SUBJECT: REPORT OF THE MEETING TO DISCUSS DOSE MODELING SCENARIO(S) IN

CONNECTION WITH THE PREPARATION OF THE DECOMMISSIONING PLAN FOR THE MICHIGAN DEPARTMENT OF NATURAL RESOURCES SITE, BAY

COUNTY, MI

MEETING REPORT

Contaminated Zone Thickness (meters)

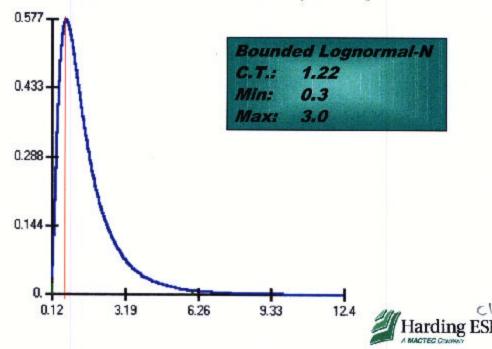
- -After some discussion, the NRC staff suggested that a triangular distribution may be more appropriate for the contaminated zone thickness than the bounded lognormal-N distribution.
- -NRC staff indicated that the licensee needs to discuss why values other than the RESRAD default values are used for parameter distribution, such as thorium distribution coefficient (K_d).
- -NRC staff indicated that the RESRAD probabilistic method can be used for calculating dose and performing sensitivity analyses, but it should not be used for calculating DCGLs. The RESRAD deterministic method should be used for the back calculations of the DCGLs.
